SUBDIVISION REPORT - CONCEPT/DEVELOPMENT PLAN

▶ **FILE #:** 10-SC-23-C
10-C-23-DP

▶ **SUBDIVISION:** MAYER PROPERTY SUBDIVISION
▶ **APPLICANT/DEVELOPER:** HOMESTEAD LAND HOLDINGS, LLC
OWNER(S): Michael and Sarah Mayer

▶ **PROPOSED USE:** Attached and detached residential subdivision

Sheet
C103
SHEET 4 OF 6

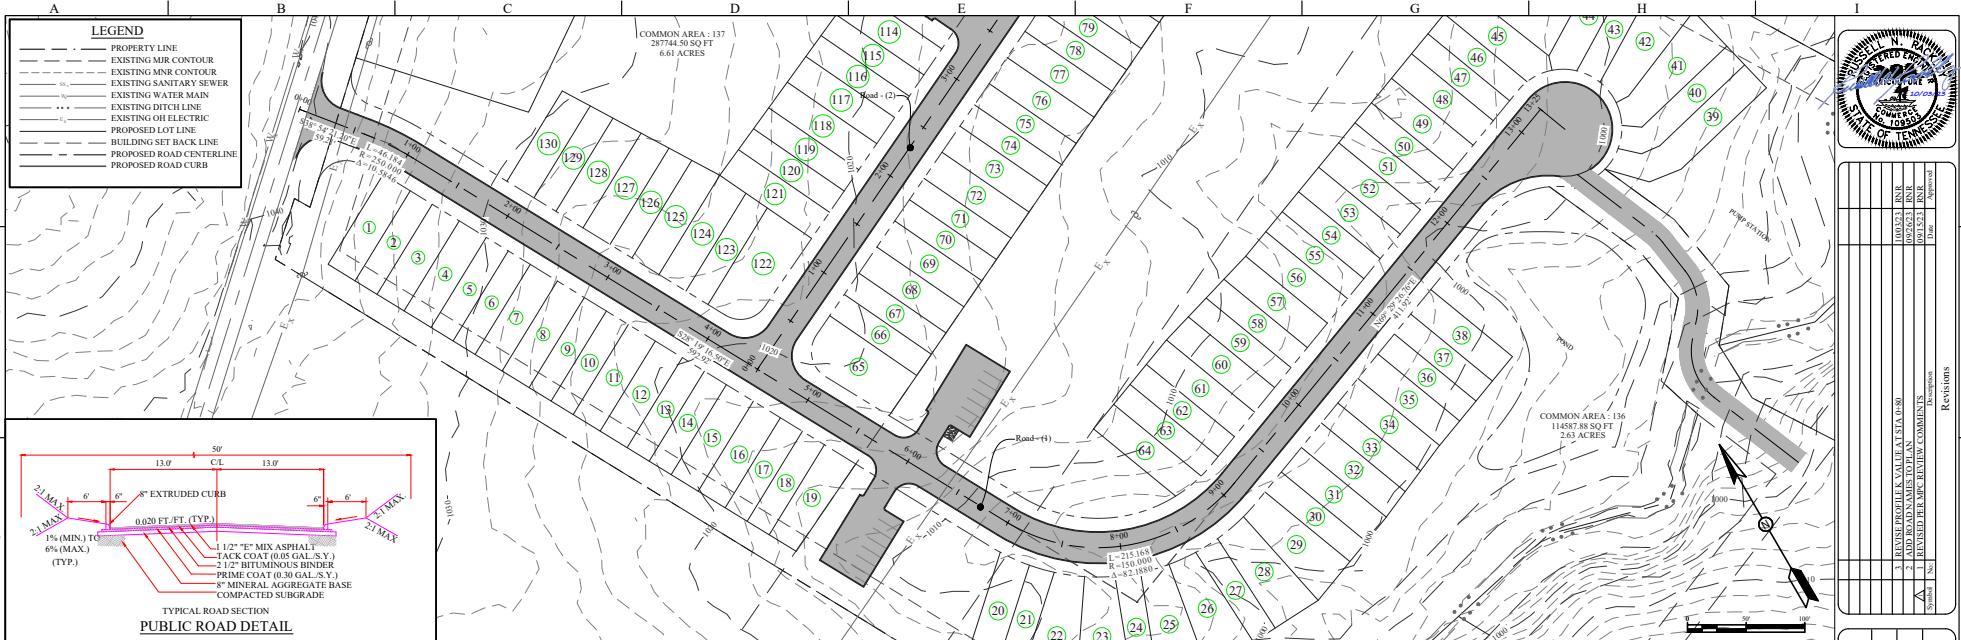
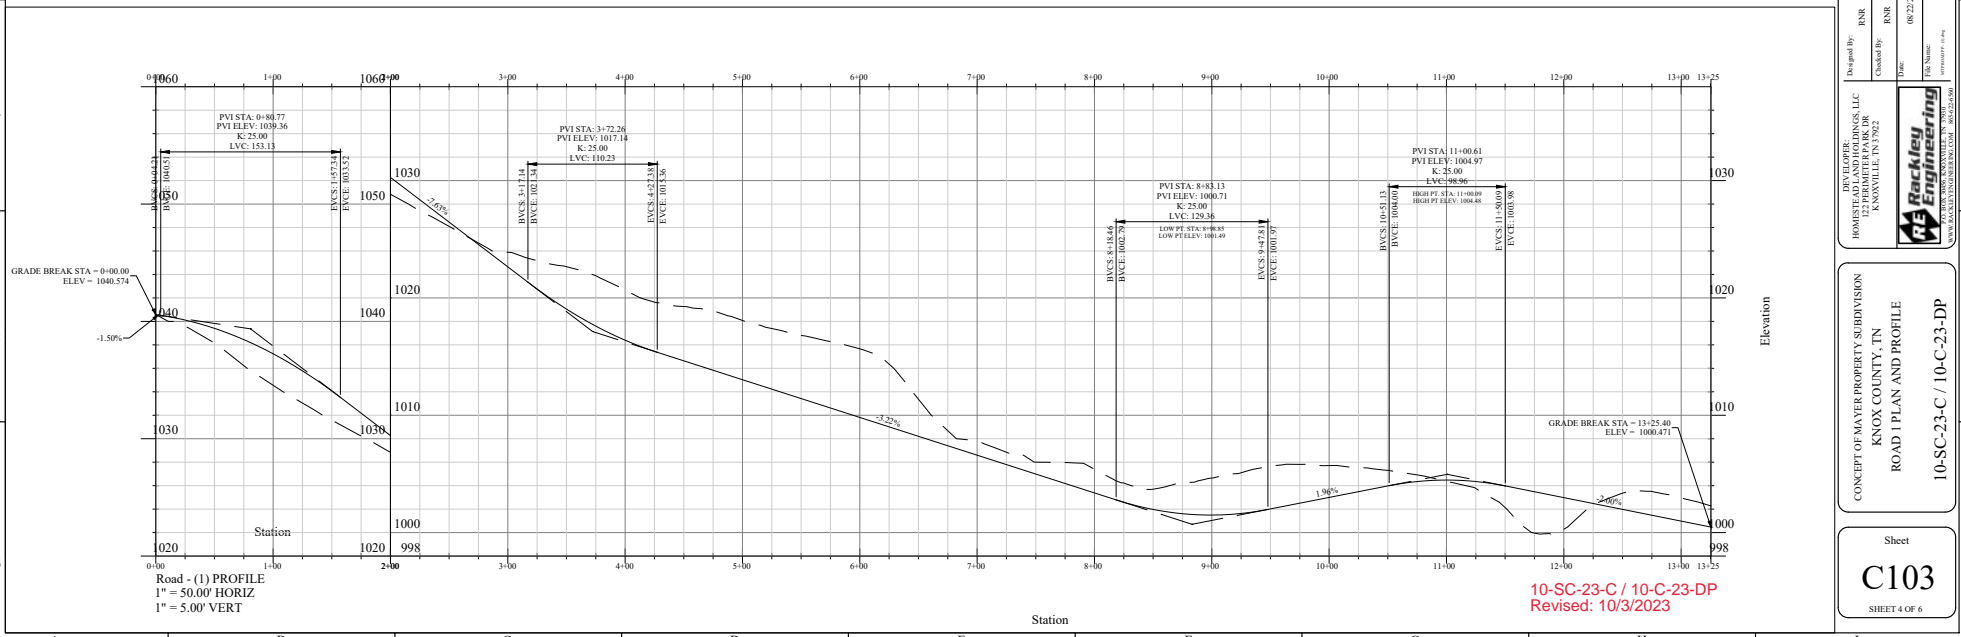
- 5) Providing a 200 ft sight distance easement on the inside of the Road 1 horizontal curve at STA 8+00.
- 6) During the design plan phase, Knox County Engineering and Public Works can approve a reduction of the pavement width to 22 ft wide and the right-of-way width to 40 ft, as an alternative design standard.

Alternative Design Standard #2: The request is to reduce the minimum horizontal curve from 250 ft to 150 ft on Road 1. The inside of this curve does not have houses, so the sight distance through this curve will remain open. A sight distance easement of 200 ft is required through the curve.

1. ~~Reduce the minimum vertical curve on Road 1 from K=25 to K=20 at STA 0+50~~

Variations: The concept plan was revised on 10/3/2023 to not require a variance.

Variance not required based on revised concept plan sheet C103 dated 10/3/2023

Sheet
C104
SHEET 5 OF 6

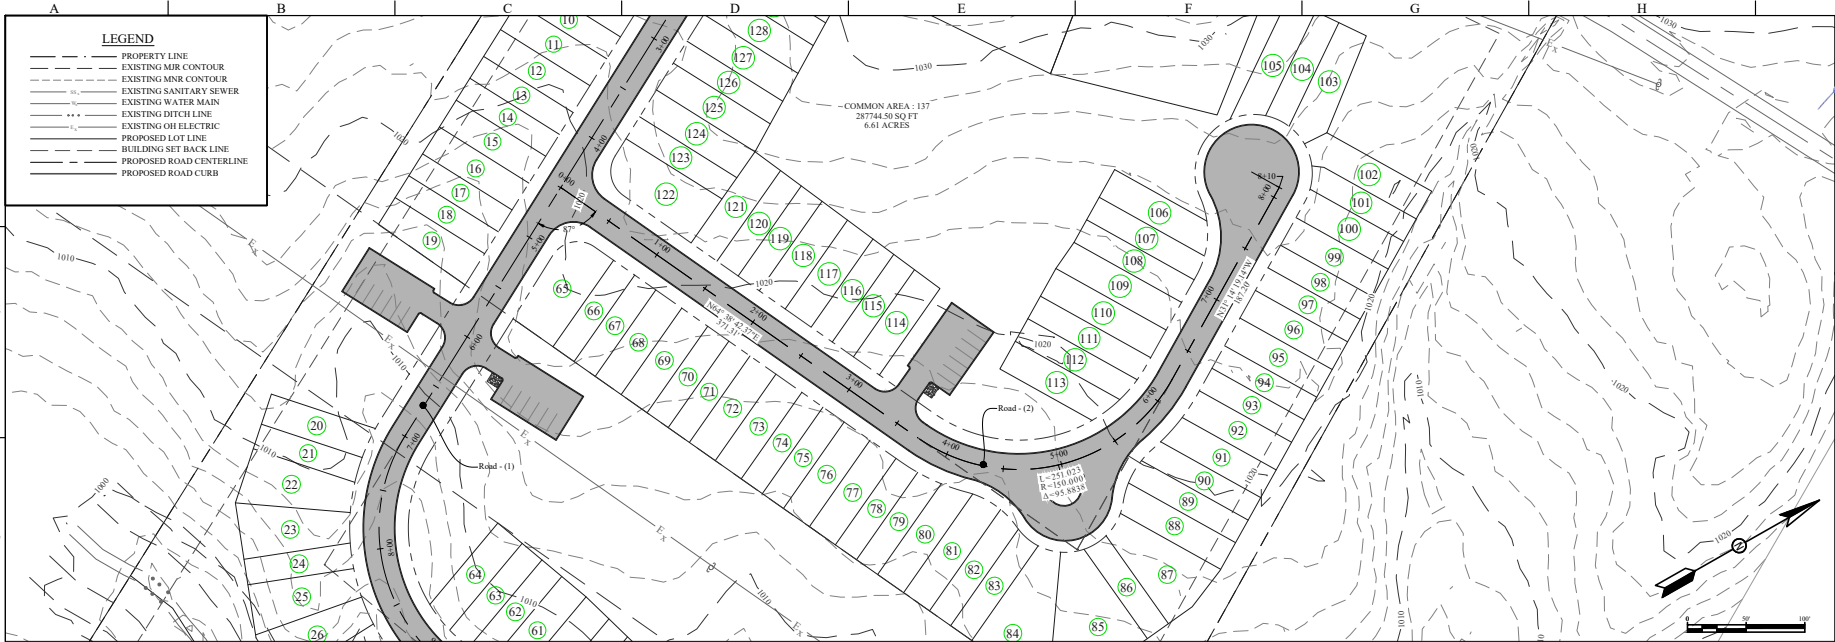
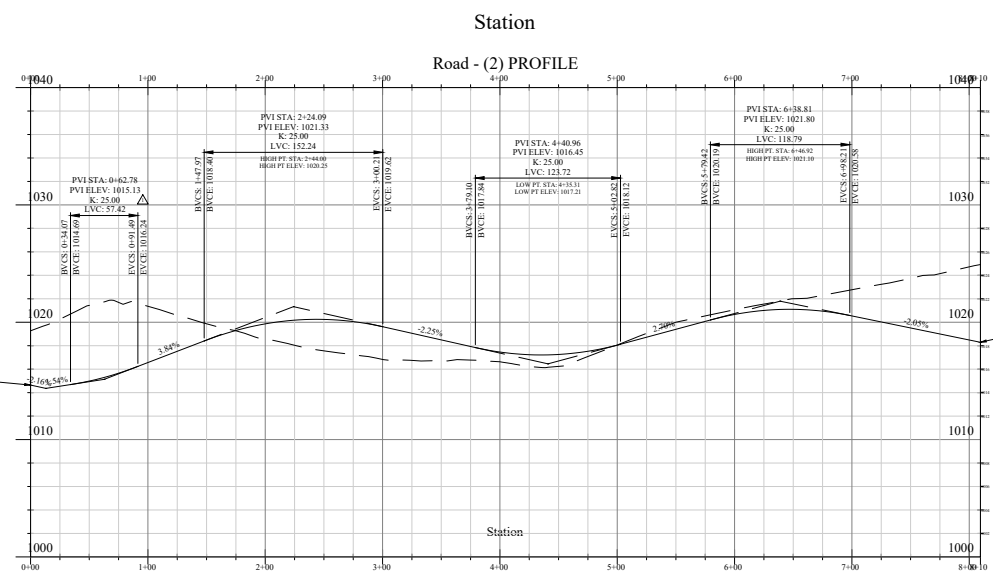
- 4) Approval of the Road 2 bulb design that provides access for lots 82-88 by the Knox County Department of Engineering and Public Works during the design plan phase.

Alternative Design Standard #1: This request is to reduce the minimum 25 ft lot frontage for residential lots to 22 ft for interior lots of grouping of attached houses and to 20 ft for the lots on the Road 2 bulb. Section 3.03.B.1. of the Subdivision Regulations allows the Planning Commission to reduce the minimum street frontage to 20 ft for attached house lots if guest parking is provided throughout the development. Guest parking is provided on Road 1 and Road 2.

Existing Sign on Millertown Pike

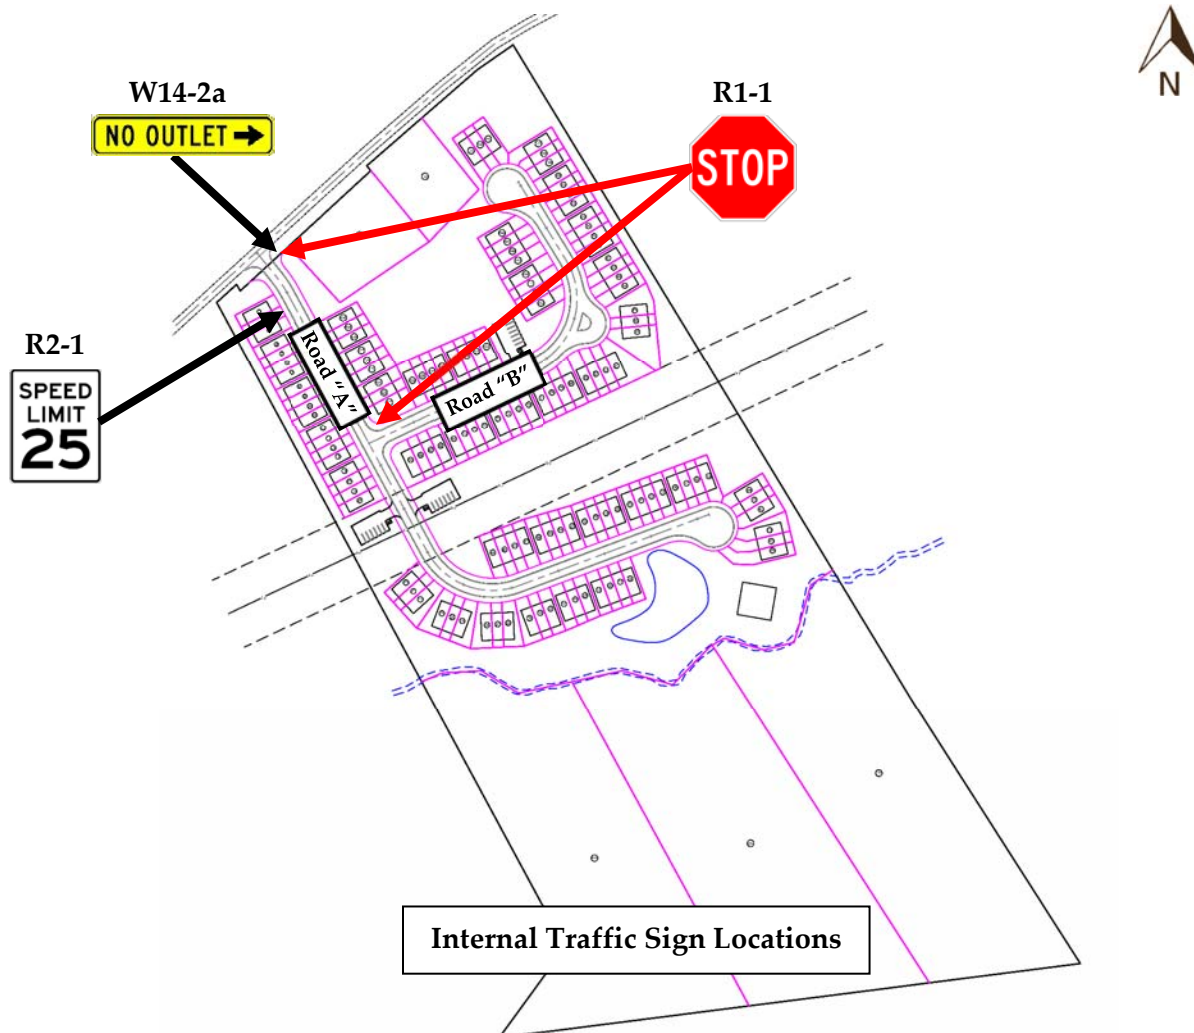
- 1d) Intersection sight distance at the proposed Road Entrance at Millertown Pike must not be impacted by future landscaping or signage. Based on a posted speed limit of 40-mph on Millertown Pike, the required intersection sight distance is 400 feet for exiting left and right-turning vehicles. The site designer must verify that these distances will be available. An existing sign is posted on the south

side of Millertown Pike along the fence line, west of the Proposed Entrance location. The sign states, "Welcome / Arminda Community". It is assumed that this sign will be impacted due to the construction of the new subdivision and entrance. If relocated, it should be posted at an appropriate location that does not impact sight distance from the Proposed Entrance.

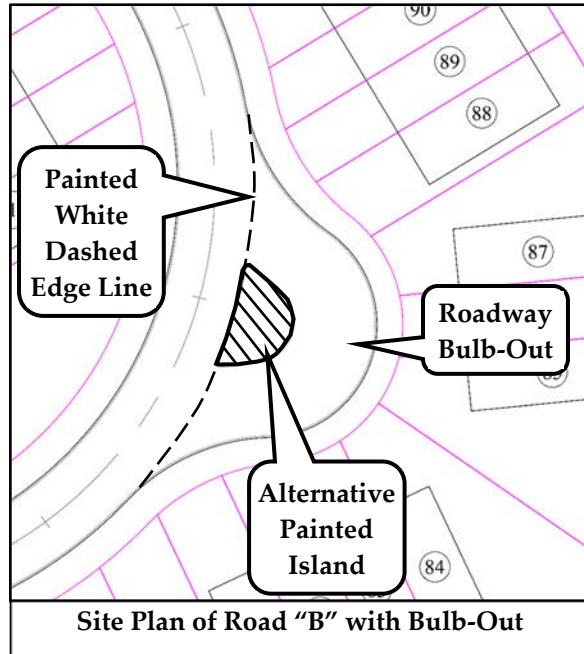
2e) Road "B" will have a bulb-out constructed along its length, accommodating access to several proposed lots in a corner of the development property. Construction of this bulb-out will create a large pavement area without traffic control on a horizontal road curve. At a minimum, it is recommended that a 4" white dashed pavement line be applied to the outside edge of the roadway adjacent to the bulb-out. Other potential traffic controls that should be considered include a striped or raised delineated island.

Other potential traffic controls that should be considered include a striped or raised delineated island. Details regarding potential traffic controls at these bulb-outs should be discussed in the detailed design phase with Knox County Engineering.
